- f. **2025-010839-HDRB, 433 Calle La Paz**, Downtown & Eastside Historic District, contributing, Martinez Architecture Studio, agent for John C. Gregory and Pamela S Austin Revocable Trusts, owners, requests primary façade designation of the main residence, a historic status review with primary façade designation, if applicable, for a casita and a garage structure.

PROJECT 2025-010839-HDRB, 433 Calle La Paz, Downtown & Eastside Historic District, contributing,
DESC: Martinez Architecture Studio, agent for John C. Gregory and Pamela S Austin Revocable Trusts, owners, requests primary façade designation of the main residence, a historic status review with primary facade(s) designation, if applicable, for a casita and a garage structure.

CASE NUMBER: 2025-010839--HDRB

PROJECT TYPE: Historic Status Review

1 EXISTING WEST ELEVATION
A-4.1 SCALE: 1/4" = 1'-0"

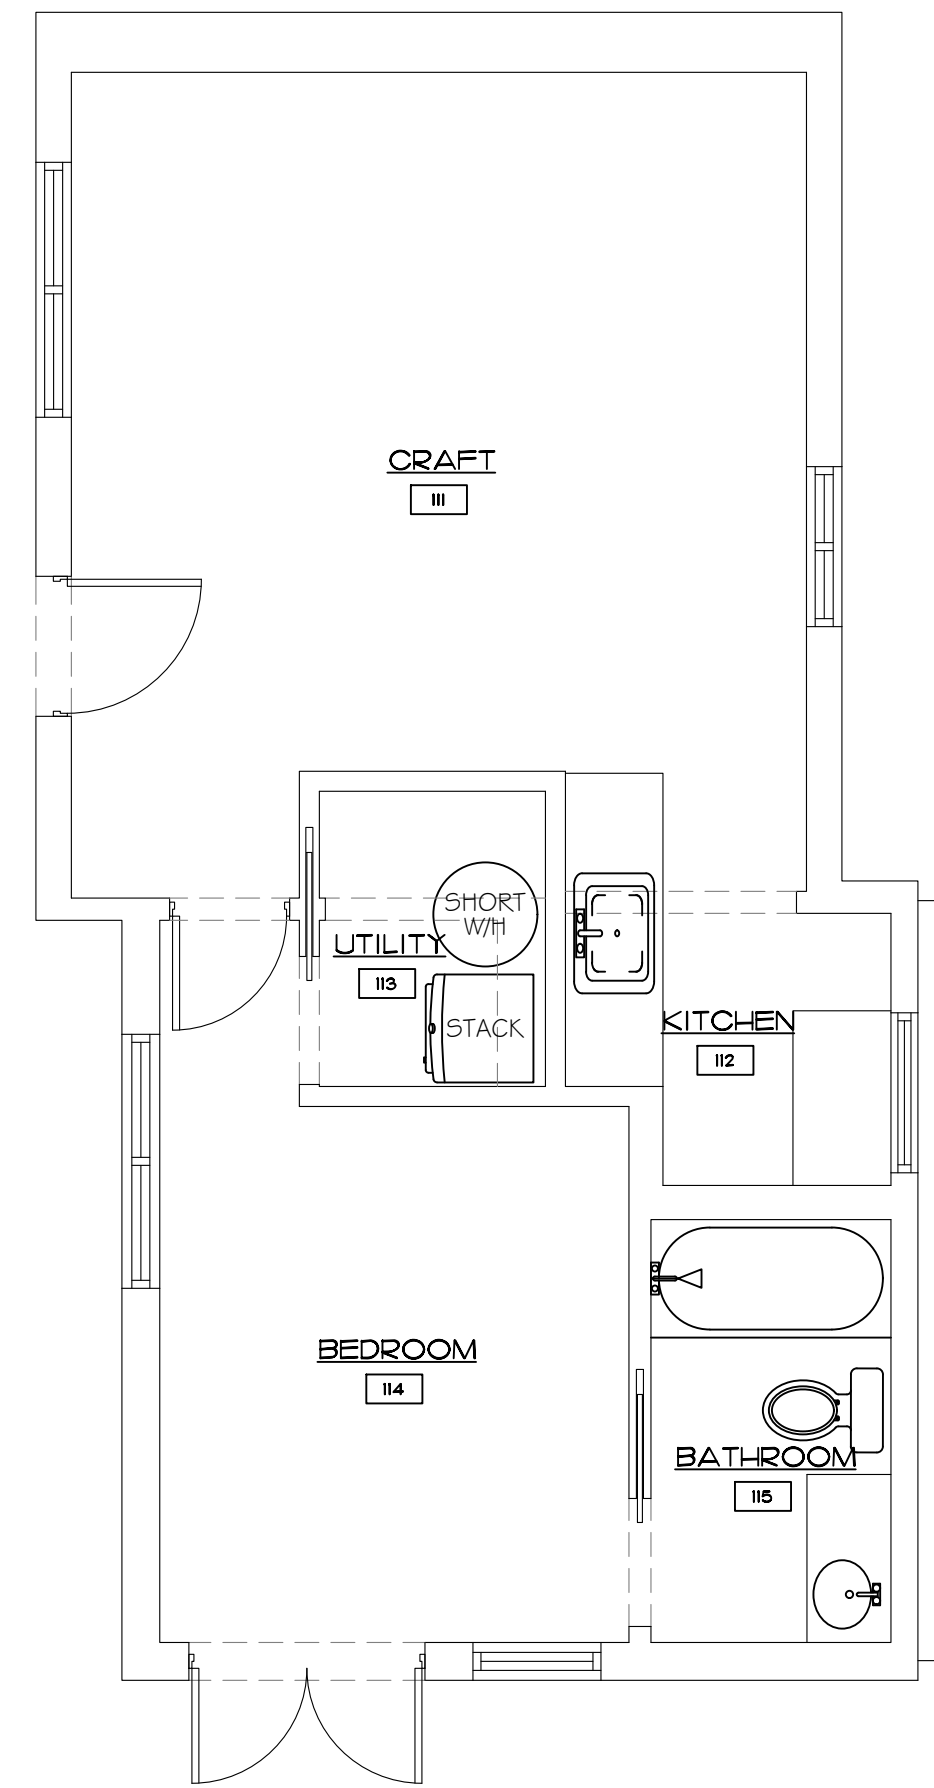
Acting Chair Bienvenu asked staff to address the west facade of the primary residence, as it was indicated that the south and the east were mentioned as not being primary in the past, which implies that both the north and the west have been considered primary. Secondly, that west elevation was noted by the HCPI as the oldest portion of the house, and it's quite visible from the street. It's by far the most visible portion of the house from the street, and it seems to retain at least one, if not two, historic windows. He asked if there was any reason why the west was not recommended to be primary as well, or would staff agree that that could also be considered primary?

Acting Chair Bienvenu asked why staff wouldn't recommend the west, the very prominent west facade that's the oldest portion of the house, and seems to have been considered primary in the past to retain it or to be designated formally tonight as also primary.

Ms. McCulley stated it was an attempt to limit the number of primary facades.

Director Lamboy pointed out that while at the site visit earlier in the day, there is a window replacement on the south elevation closest to Calle La Paz that is recent, which was not approved, and the window approved in 2001 had a different mutton pattern than what has been replaced. There is still disturbed stucco around the window. The problem with illegal window replacement is that there are also building code standards that apply and have to do with fire rating. Because this property is not five feet stepped back from the property line. She shared this to alert Mr. Martinez that this issue will come up when a building permit is being sought. She also stated that the applicant should not talk about what is being planned as a basis for designating primary facades, but rather whether the finishes or features are historic.
